## Request for Information (“RFI”)

Harrison, Town-Village Recreation Center Phase 2  
270 Harrison Avenue  
Harrison, NY 10528

**ISSUE DATE:** 01/07/2025**RFI No.** 014**PROJECT NUMBERS:** 2020-1005 /**REQUESTED REPLY DATE:**  
**COPIES TO:****RFI DESCRIPTION:** *(Fully describe the question or type of information requested.)*

**S102**

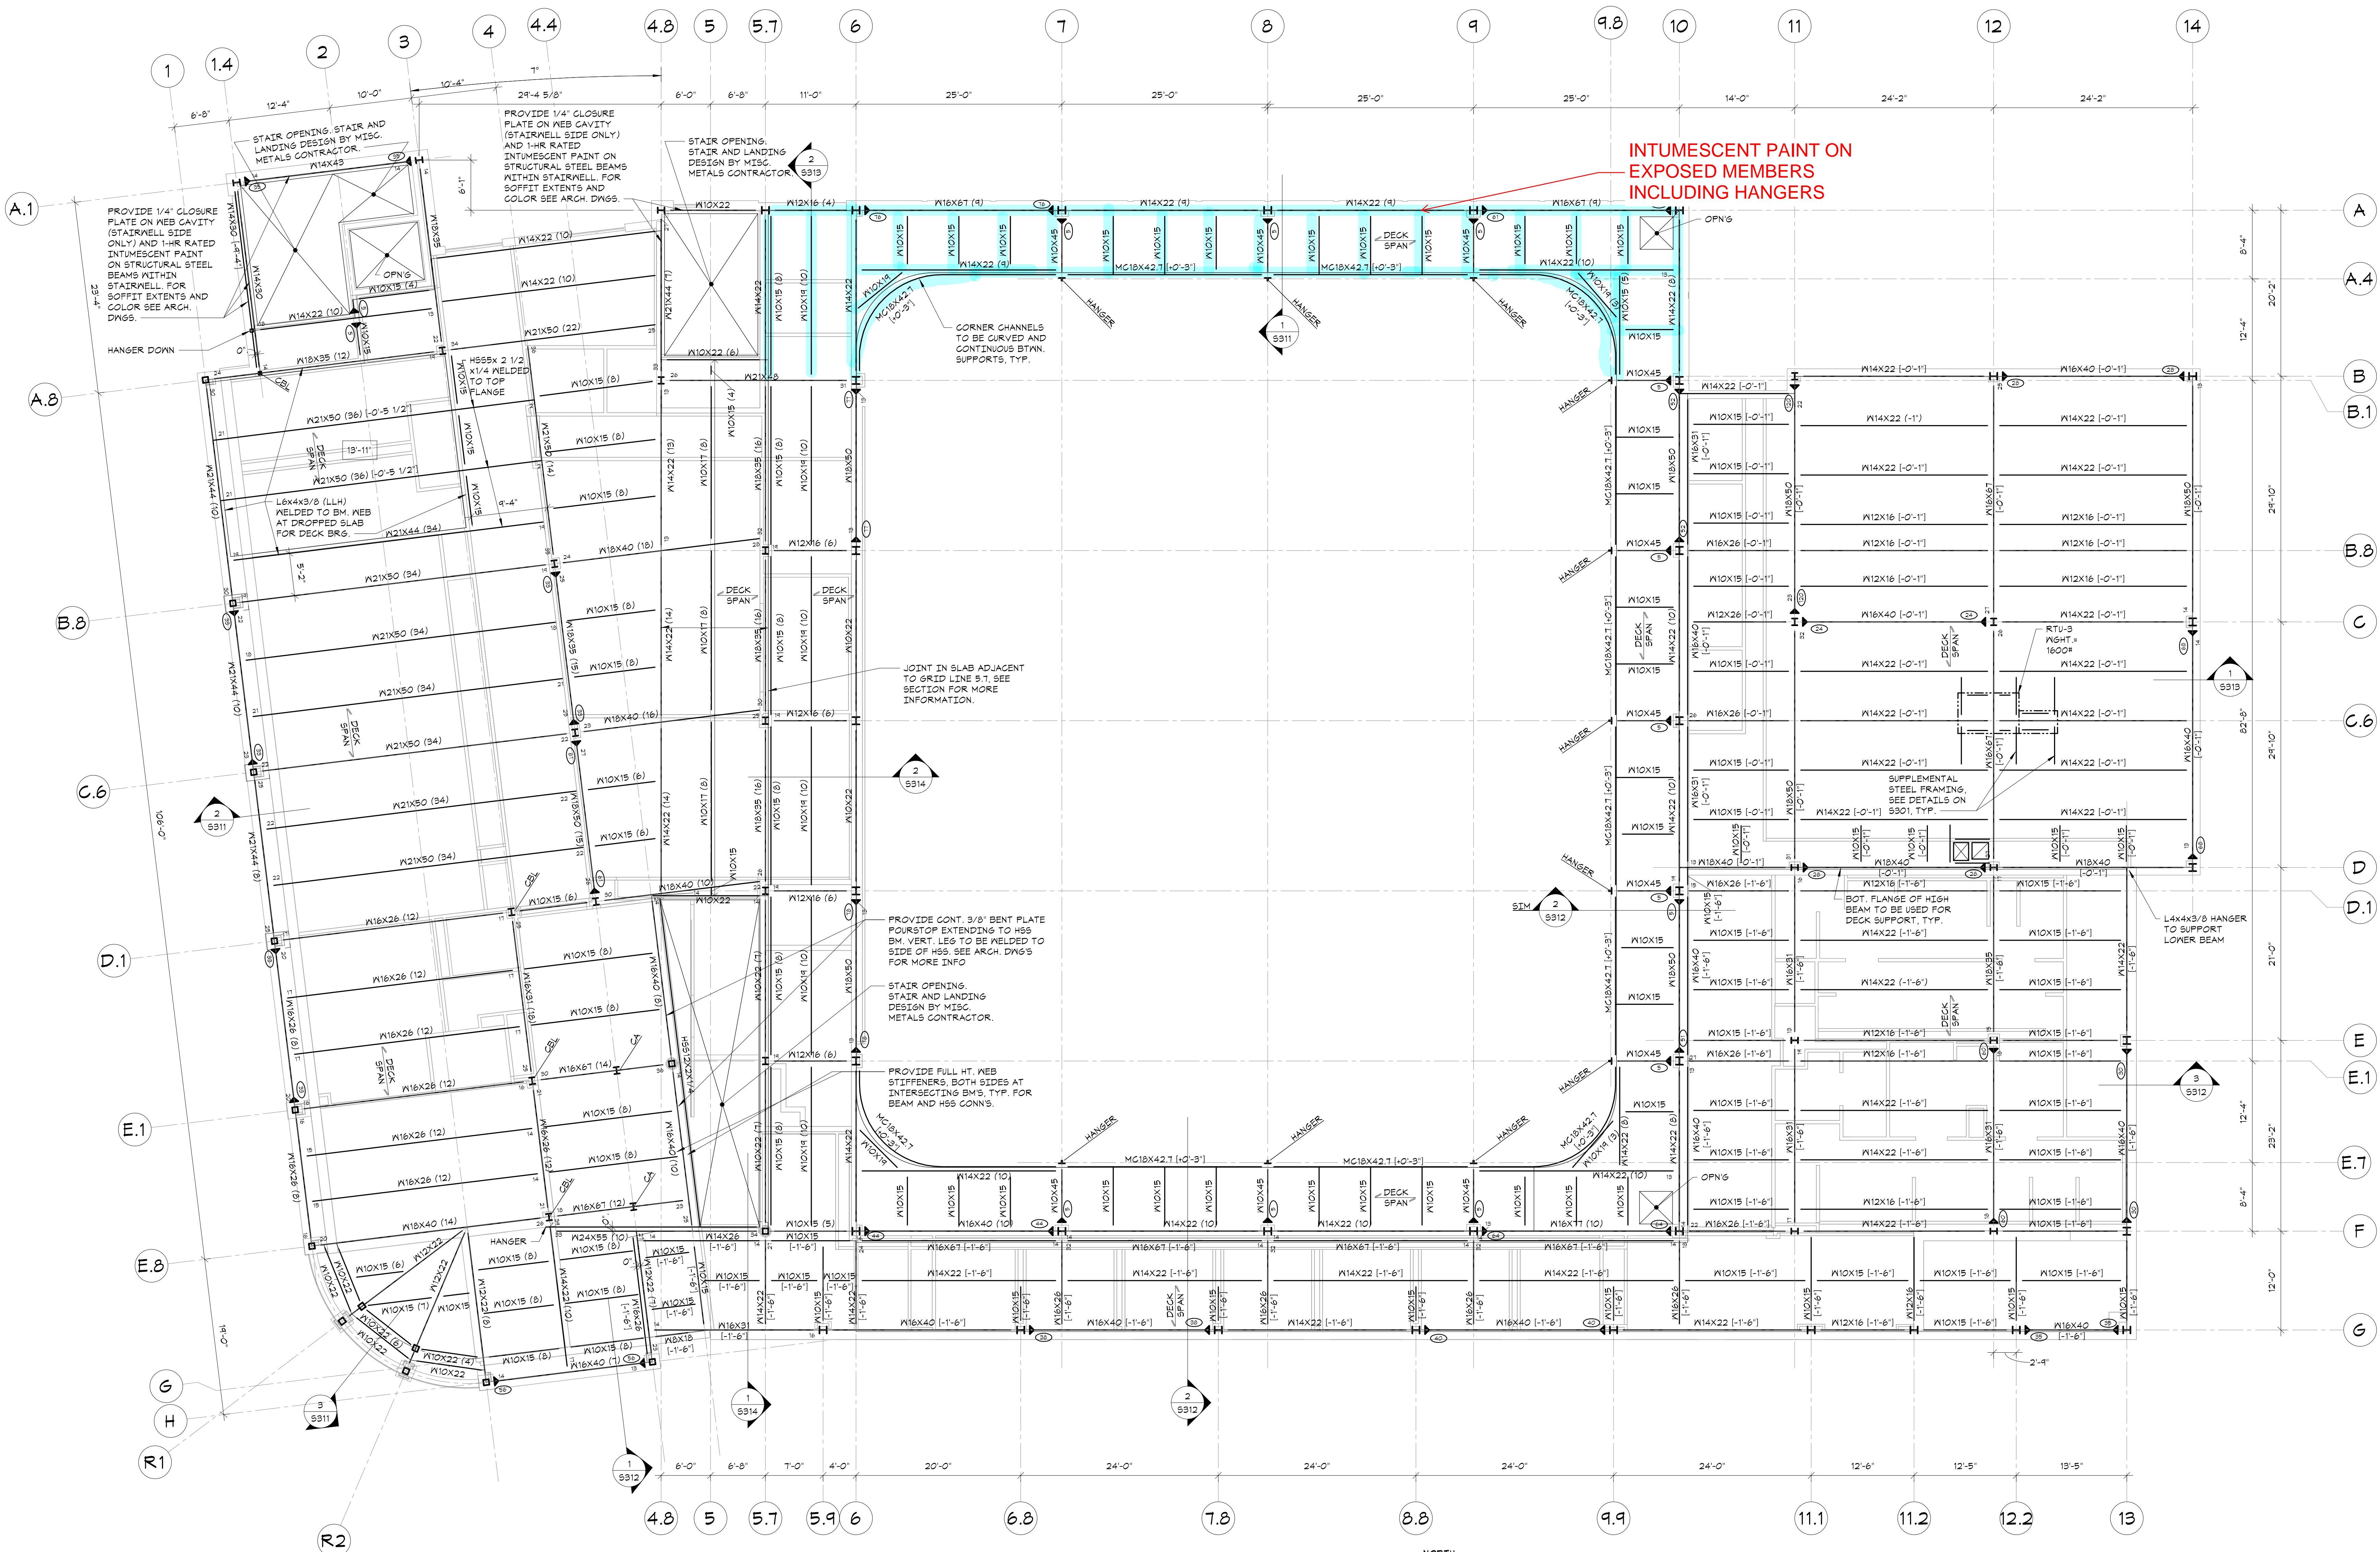
On reference to bid addendum #4, question #61: Drawing CC001 establish the building as type IIB: 0 hrs fire resistant for building elements; if fireproofing is necessary at the gymnasium please clarify the extension of the intumescent paint (trusses and beams?); another issue to consider is the roof deck, without any concrete on it, the deck itself will need to be rated for 1 hour as well as the beams.; there is not a UL design that supports the deck achieving a fire rating with intumescent paint. Please advise.

SEE ATTACHED STRUCTURAL PLANS INDICATING THE EXTENTS OF THE INTUMESCENT PAINT AT THE GYM. AS THE ROOF FRAMING IN ITS ENTIRETY EXCEEDS 20' ABOVE THE FLOOR THE ROOF ASSEMBLY IS NOT REQUIRED TO BE RATED.
